# Town of Hilton Head Island Regular Design Review Board Meeting

Tuesday, October 28, 2014

BOYS & GIRLS CLUB  
 Hilton Head Island, SC  
 October 7, 2014

# THE FIRST TEE OF THE LOWCOUNTRY

# The First Tee of the Lowcountry Maintenance Facility 1,000 SQFT.

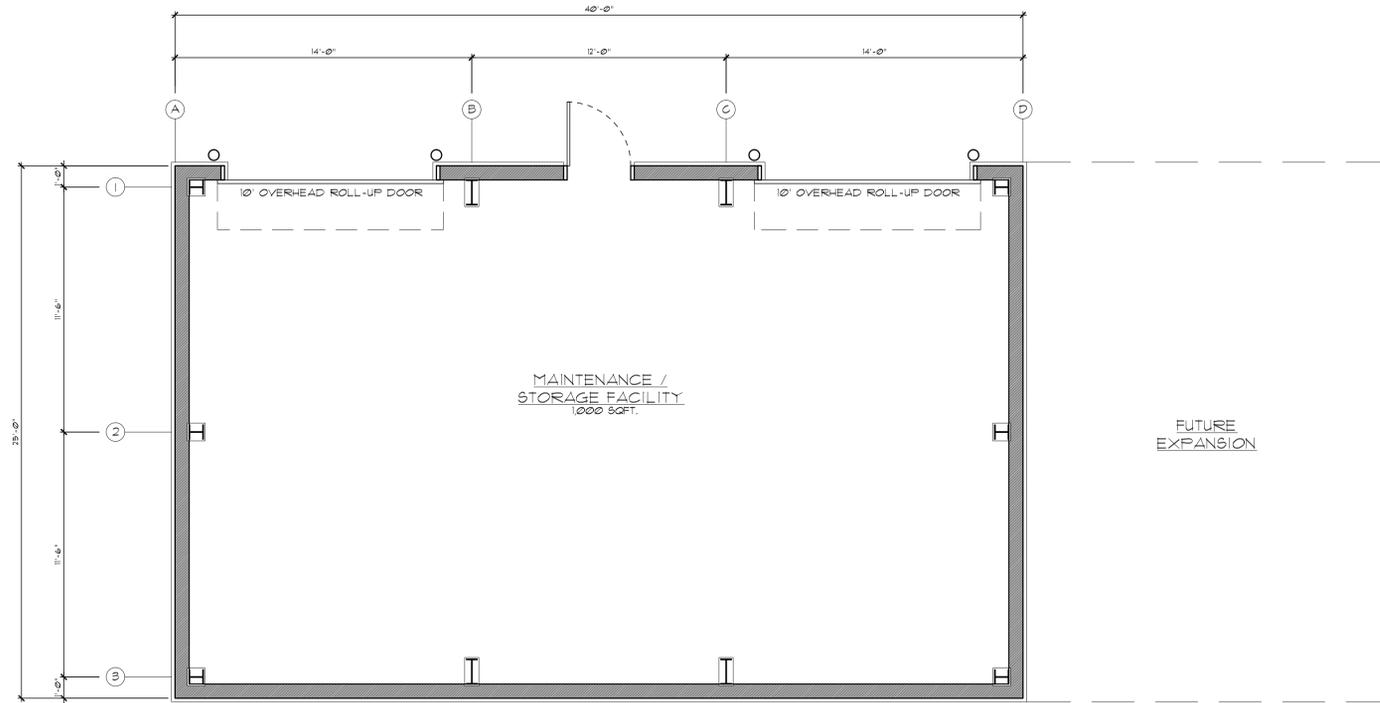
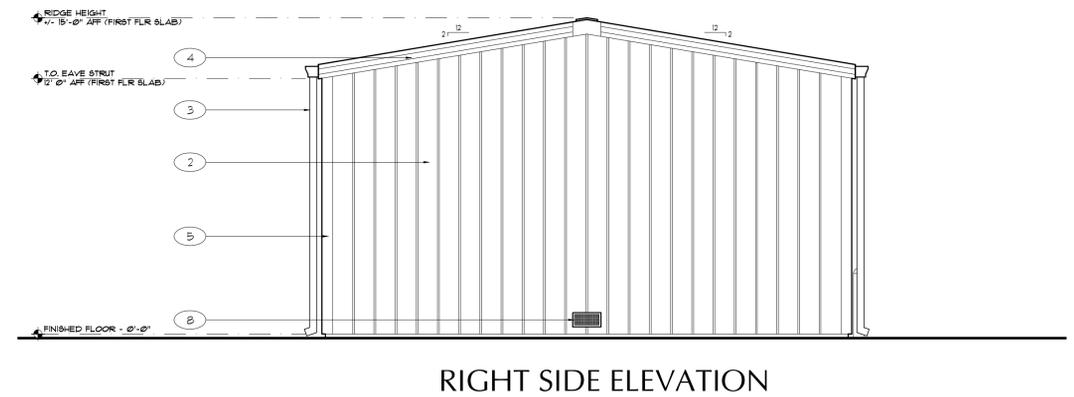
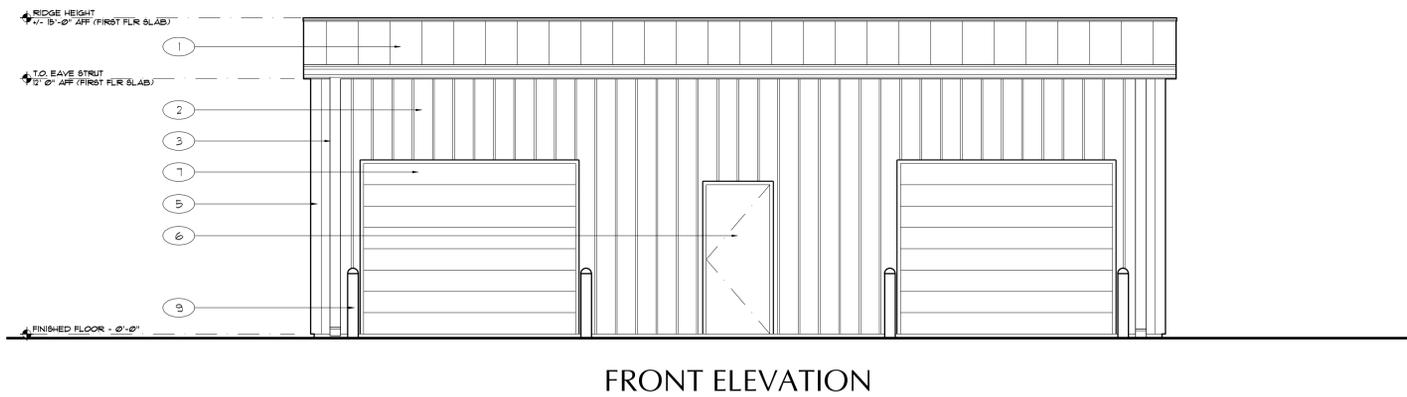
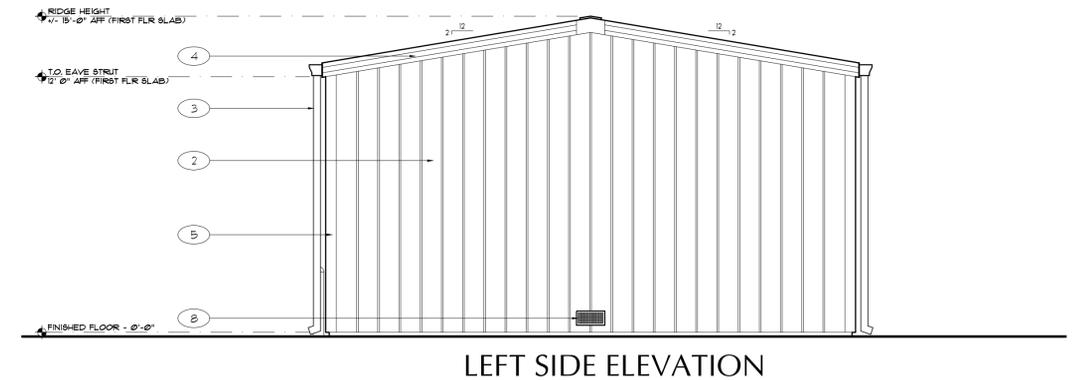
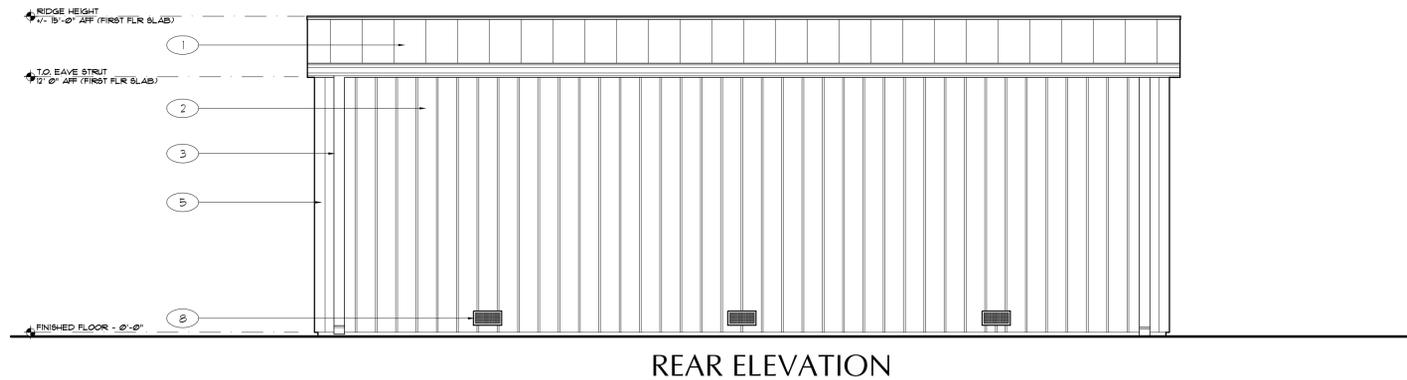
structure				
Human scale is achieved by the use of proper proportions and architectural elements	<input checked="" type="checkbox"/>	<input type="checkbox"/>	<input type="checkbox"/>	Trellis and wood awning added to building.
Utilizes a variety of materials, textures and colors	<input checked="" type="checkbox"/>	<input type="checkbox"/>	<input type="checkbox"/>	Mostly metal – wall panels and awning roof and stainless steel wire mesh. Some wood elements added – trellis, columns, awning, screen.
Incorporates wood or wood simulating materials	<input checked="" type="checkbox"/>	<input type="checkbox"/>	<input type="checkbox"/>	
Windows are in proportion to the facade	<input checked="" type="checkbox"/>	<input type="checkbox"/>	<input type="checkbox"/>	
Details are clean, simple and appropriate while avoiding excessive ornamentation	<input checked="" type="checkbox"/>	<input type="checkbox"/>	<input type="checkbox"/>
